**A38 Derby Junctions**

**Appendix 3.3: Options Assessment –  
Little Eaton – Options 2A, 2B, X and X1**

## **Options Assessment: Little Eaton Options 2A, 2B, X and X1**

**Report No: 47071319-URS-06-RP-RDN-024  
July 2016**

Drawing Title  
**LITTLE EATON  
OPTION X  
GENERAL LAYOUT  
PLAN**

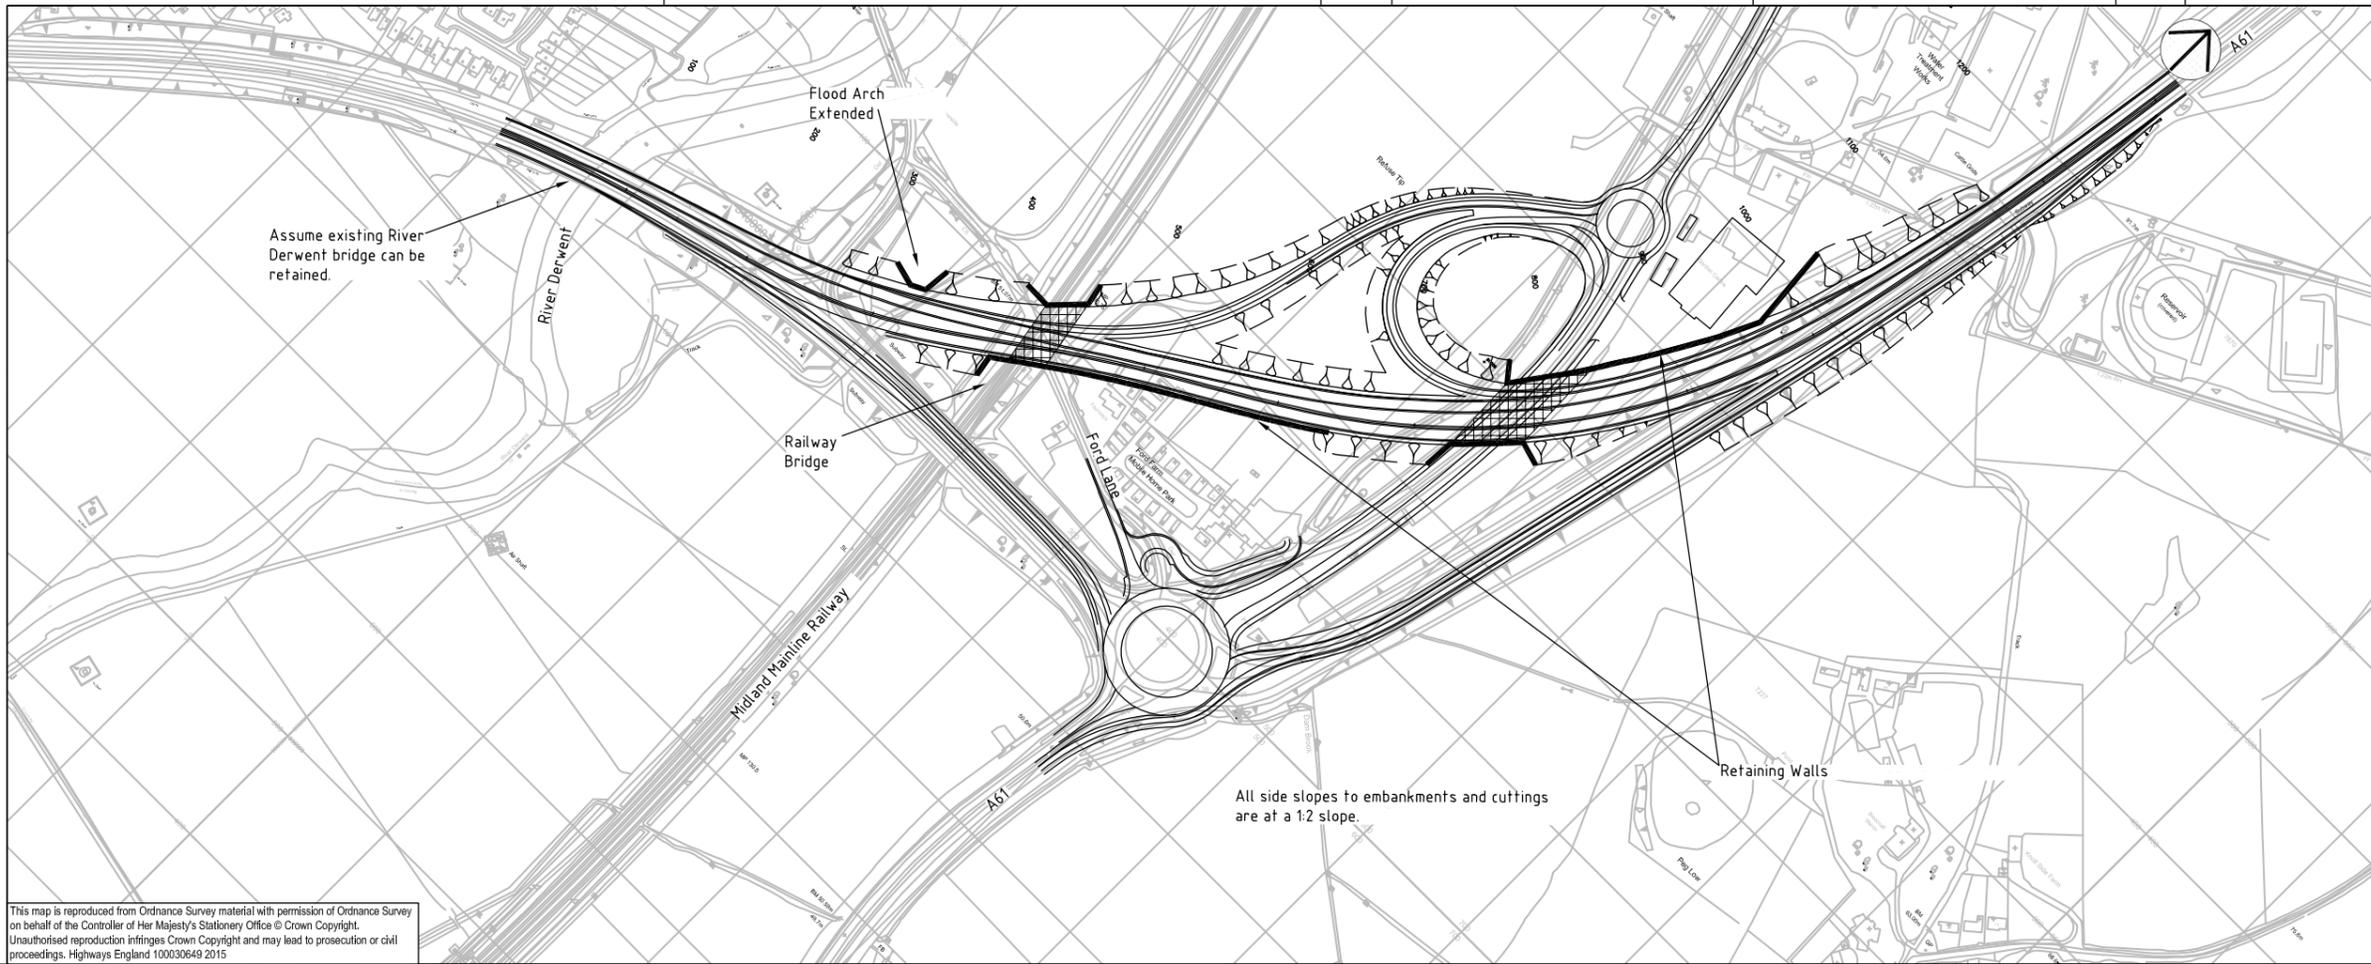
Reference		Description of the Alternative Option
Option X		This Option was developed with the intention of retaining the existing A38 in order to balance the alignment between Little Eaton and Breadsall. The option retains the A38 on its existing horizontal and vertical alignment, diverts the B6179 to the north of the garden centre to pass under the A38 to a new roundabout on the A61. See drawing no. HA514503-URS-06-DR-GD-25.040.
Submitted by:		
David Hall (Little Eaton)		
Alternative option for Little Eaton Junction		
Objectives Categorisation		
Objective Description	Score	Comments
<b>Objective 1</b> 'To reduce congestion and increase reliability of journey times on the strategic corridor'	2	<p>Compared to option 2, the traffic benefits to A38 would be marginally reduced. This is a result of the sharper bend in the horizontal alignment requiring a lower design speed and speed limit, thereby restricting vehicle speeds and extending journey times. Although the difference would be small for each individual journey, the effect would be multiplied across all A38 through traffic movements.</p> <p>Traffic movements between the northbound A38 and A61 will be significantly disadvantaged by the excessively longer link manoeuvres as follows:</p> <ul style="list-style-type: none"> <li>- Trips from A38 northbound heading into A61 Derby (South) would be required to exit the A38 and use the new B6179 link road around the garden centre, under the A38 and then travel south to the A61. This increases journey distance for this manoeuvre compared to the Presented Option from 719m to 2,116m: an increase in trip length of 1.40 km (0.9 mile).</li> <li>- Similarly, trips from A61 heading to the A38 North would be required to use the new B6179 link road to the east of the A38, around the garden centre and then south to join the A38 via the looped slip road. This increases the journey distance compared to the Presented Option from 916m to 1,982m: a trip increase in length of 1.07km (0.67 mile).</li> <li>- The large A61 to A38 North (out of Derby) movement would circulate in front of the large into-Derby traffic movements; the A38 northbound to A61 (via the new link road) and the A38 southbound to A61. This would result in lengthy delays for traffic entering Derby, particularly in the AM peak period. To prevent A61 southbound vehicles blocking back onto the A38, it may be necessary to implement a traffic signal alternative to the roundabout. An alternative layout would provide better control of the vehicle queues, but substantial lane widening would be required on the approaches and departures to a traffic signal controlled junction, requiring greater landtake.</li> <li>- Trips from A38 southbound to the A61 have a free-flow filter lane in the Presented Option. With 'Option X', these trips would have to pass through a new junction (either the roundabout shown or a traffic signalled alternative as noted above). For these movements this arrangement would induce additional delays to all journeys at all times of the day.</li> </ul> <p>Overall, the combination of reduced traffic improvements for A38 through-traffic and the difficulties associated with traffic using the slip roads and link road result in Option X performing substantially worse than the Presented Option or Option 2.</p>

<b>Objective 2</b> 'To minimise traffic disruption due to construction works and incidents'	3	<p>The option makes significant use of the existing A38 carriageway and does not propose much online work other than removing the existing Little Eaton roundabout thereby minimising disruption.</p> <p>Options for construction of the new underbridge are:</p> <p>(i) construct the new RC box structure on the adjacent land and slide in using box-jacking techniques. This is a complex and costly option which will require adequate adjacent land (for example to the east of the A38) to be available but no disruption to A38 traffic is expected; (ii) lengthy closure of A38 to enable the new RC structure to be built insitu using the cut and cover method. This will be highly disruptive to traffic although the time period for the closure could be reduced by using precast box units. A long term closure is considered to be unfeasible given the lack of suitable diversion routes. The closure of the A38 is expected to increase traffic flows through Little Eaton and Breadsall regardless of the signed diversion route; (iii) temporary diversion route through adjacent green belt land between the A38 and Breadsall in a similar but shorter manner to the Southern Sweep option; or (iv) construct the new structure on adjacent land and slide in (dependant on availability of land) during a short closure of several days with diversions along the B6179.</p> <p>Due to the significant traffic benefits it is assumed that option (i) - box jacking, would be the final solution. The underbridge would need to be in place before the new A61 junction could be constructed or the existing B6179 closed in order to ensure that as many turning movements as possible could be maintained during construction.</p> <p>Construction of the B6179 link road can be carried out offline with minimal disruption.</p> <p>Constructing the new A61 roundabout could be undertaken off-line but the tie-ins would require online works and hence would disrupt traffic flows. During construction it may not be possible to maintain all turning movements at the junction.</p> <p>On this basis, the objective is scored lower than for Option 2 and comparable to the Presented Option.</p>

<b>Objective 4</b> 'To minimise impacts on both the natural and built environment, including designated landscape/biodiversity features'	2	<p>Compared to the Presented Option and Option 2, Option X would (i) reduce landscape and visual impacts as scheme would not be on embankment; (ii) avoid land take impacts upon the mobile home park; (iii) result in impacts upon the garden centre buildings due to the new link road (as compared to the car park), however it is not expected to threaten business viability as the existing highway land could be released to the garden centre; (iv) potentially reduce flood risk impacts due to the avoidance of an embankment in areas susceptible to flooding; (v) require additional construction in an area of known historic landfilling; (vi) result in the loss of recycling business due to proposed location of the access road to the mobile home park; (vii) potentially impact National Cycle Route (NR54) due to the configuration of the junction and the arrangement of the new roundabout to the A61; (viii) impact on the setting of Breadsall Conservation Area due to the new link road moving traffic closer to Breadsall Manor; (ix) impact on non-designated ecology assets plantation near the garden centre (Site Code ER017/3) and Old Derby Canal (Site Code ER003/3) along the A61; (x) reduce works in the Derwent Valley World Heritage Site; (xi) avoid access issues associated with maintaining business viability for Talbot Turf; and (xii) potentially reduce car parking space and passing trade for the existing Starbucks site due to the alignment and visibility requirements for the new link road may threaten business viability.</p> <p>Whilst Option X would reduce some environmental effects as compared to Presented Option and Option 2, the score for this objective would be 2 as there remain some policy conflicts.</p>

Reference		Description of the Alternative Option
Option X		This Option was developed with the intention of retaining the existing A38 in order to balance the alignment between Little Eaton and Breadsall. The option retains the A38 on its existing horizontal and vertical alignment, diverts the B6179 to the north of the garden centre to pass under the A38 to a new roundabout on the A61. See drawing no. HA514503-URS-06-DR-GD-25.040.
Submitted by:		
David Hall (Little Eaton)		
Alternative option for Little Eaton Junction		
Objectives Categorisation		
Objective Description	Score	Comments
<b>Objective 5</b> 'To seek to mitigate impacts on air quality and noise'	3	Impacts on noise would potentially be marginally reduced as compared to the Presented Option and Option 2 as traffic would not be located on elevated embankment. Air effects are likely to be comparable to the Presented Option. Overall, the differences are unlikely to be substantial and consequently, Option X will be comparable to the Presented Option and Option 2.  On this basis, the objective is scored comparable to the Presented Option and Option 2.

<b>Objective 6</b> 'To improve the safety for all road users'	2	Key factors in assessing the safety of the option are (i) the radius of the bend on the A38 would be inadequate for a high speed route and would require either increasing to a similar radius to the Presented Option with consequent land take or a permanent speed limit. The assessment is based on a 40mph permanent speed limit. This is significantly below the speed limit for a rural dual carriageway. Additionally, the existing roundabout and radius has a history of HGV rollovers. For these reasons, it is anticipated that speed enforcement measures would be required. The effects on the other assessment criteria of increasing the radius have not been examined at this time. (ii) the layout of the new A61 roundabout would require some re-designing as traffic heading for the A38 northbound from the A61 cuts across the traffic heading into Derby from the A38. Additionally, there are 3no arms located within a small arc of the circulatory carriageway- in the sketched layout. The engineering drawing shows the roundabout in a modified position in order that the southbound entry slip complies with design standards without the need to widen the railway bridge; (iii) the layout of the northbound slip roads has been modified to ensure compliance with standards and improve road safety. This has led to increased radii on each loop; (iv) traffic leaving the mobile home park and the Starbucks wishing to use the A38 northbound will be required to use the new link road to the A61 roundabout and return. This lengthy manoeuvre is likely to lead to vehicles making an illegal u-turn at the northbound entry slip road nose, just to the north of where the new mobile home access meets the new B6179; (v) traffic using the A61 heading for the mobile home park will be required to use the A38 to the A6 Palm Court junction and return. The increased journey length will have a marginal adverse impact on road user safety; (vi) the submitted sketch plan showed Ford Lane, leading to the mobile home park and adjacent properties, being accessed from the northbound slip roads. This contravenes design standards as it results in a junction on a slip road. The engineering drawing shows an alternative layout with a new access from the B6179; and (vii) Although there is the opportunity to provide segregated NMU facilities along the new B6179 link road, the new roundabout junction at the A61 would be severely detrimental to safety for cyclists leaving Derby along Sustrans cycle route 54.  Overall, the option is considered to perform worse than Option 2 or the Presented Option.

<b>Objective 7</b> 'To seek to reduce severance by maintaining or providing appropriate facilities for crossing, and travelling along the route for non-motorised users'	3	The score is comparable to Option 2 as no NMU routes will be permanently severed and crossing points would be provided where required. NMU routes from the A61 towards Little Eaton could follow the new link roads with little impact. However, the direct route from the A61 to Ford Lane would be severed and the alternative would be an extensive detour.  Overall, the option is considered to be comparable to Option 2.  The safety of non-motorised users is considered in Objective 6.
<b>Objective 8</b> 'To be affordable and represent High Value for Money according to DfT's appraisal criteria'	2	Additional trip-lengths from the A38 northbound to A61 and A61 to A38 northbound will reduce the transport economic efficiency (TEE) of the option. The conflicts at the new A61 roundabout would result in additional delays and are likely to further reduce the TEE. Access to Starbucks and Ford Lane from the A38 southbound is lengthy.  Consequently, Option X will perform worse than the Presented Option and Option 2A.
